TRANSMITTAL OF DEFENSE NUCLEAR FACILITIES SAFETY BOARD (DNFSB)
RECOMMENDATION 2010-2 IMPLEMENTATION PLAN (IP) DELIVERABLE 5.5.3.6

Large-Scale Integrated Mixing System Expert Review Team review comments and resolution are also included with this transmittal.

One System Waste Feed Delivery Mixing and Sampling Program Limits of Performance and Solids Accumulation Scouting Studies Test Plan

Figure 2-3. Schematic of Remote Sampler Demonstration Test Platform

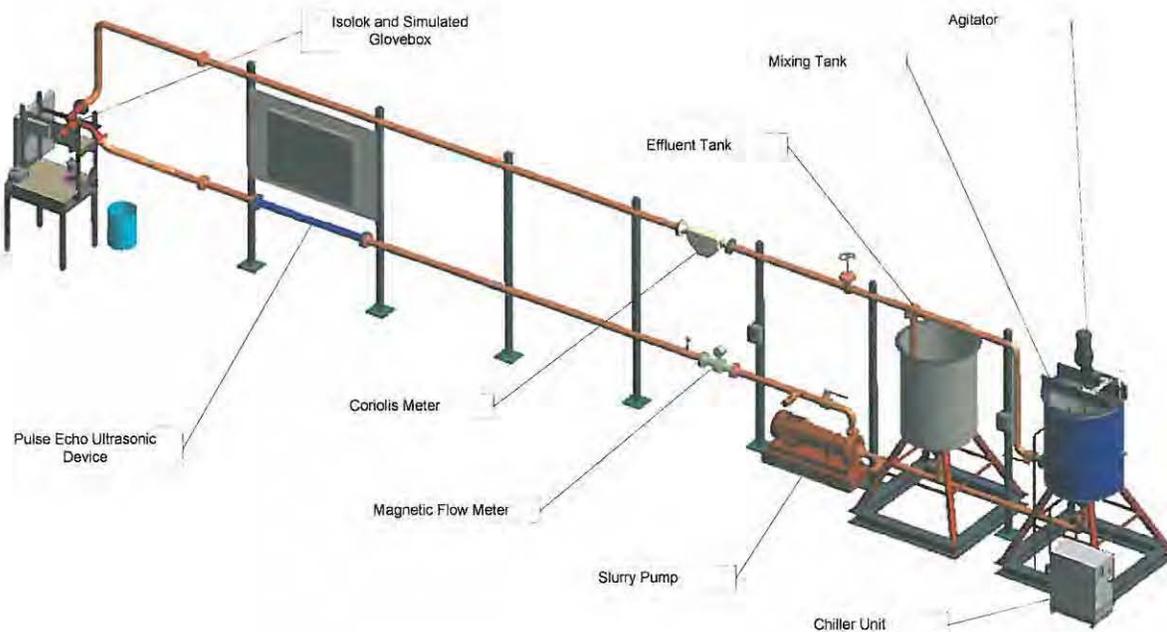
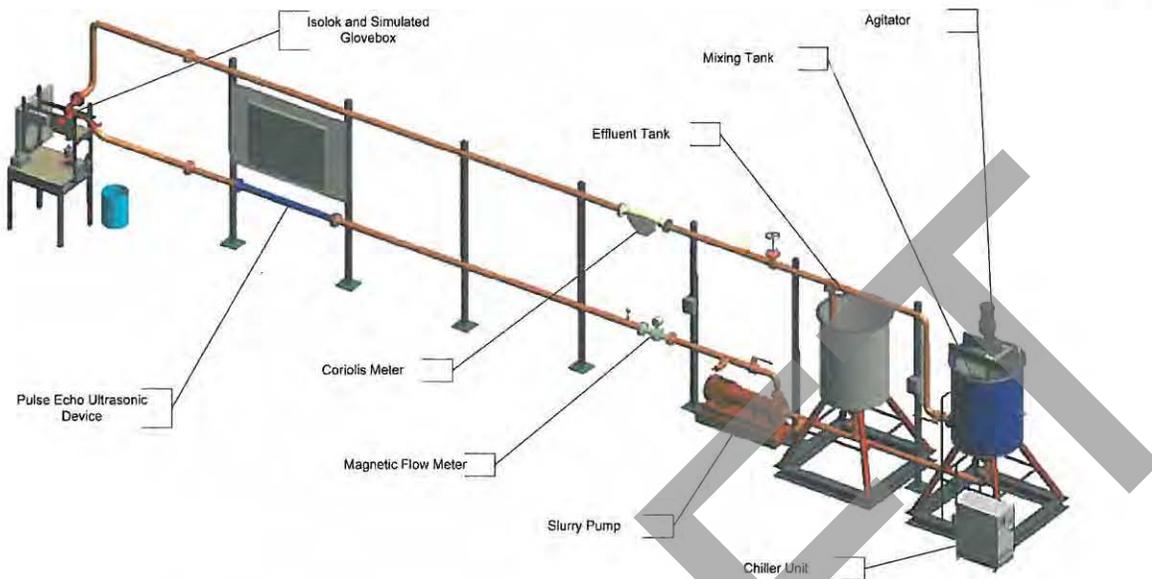
115	RKG	M	Section 2.1.3.2: Is there a contingency plan should a customized pump not be feasible?	A commercially available pump has been identified.
116	RKG	O	Figure 2.3: What is the design basis for the mixing tank and agitator? What basic data have been given to the vendor?	The vendor is being consulted on the capability of the mixer to suspend the spike particles (1/4-inch WC). The tests will not be allowed to proceed until the agitator is determined to be adequate. This is a project management control.
117	RKG	O	Page 2-12: Won't the fastest settling particles (most difficult to suspend) leave the vessel first? Unless they cannot be fluidized in the outlet pipe? The particles left behind will be the easiest to suspend that follow the flow patterns?	Historical testing shows that the earliest samples do have a higher fraction of faster settling particles but also that, because of the rotating nature of the mixing the heaviest particles are also swept up by the jets but settle in the area that is furthest away from the jets and the pump. The tank is operated to achieve solids distribution, not bottom clearing so piles are left behind.
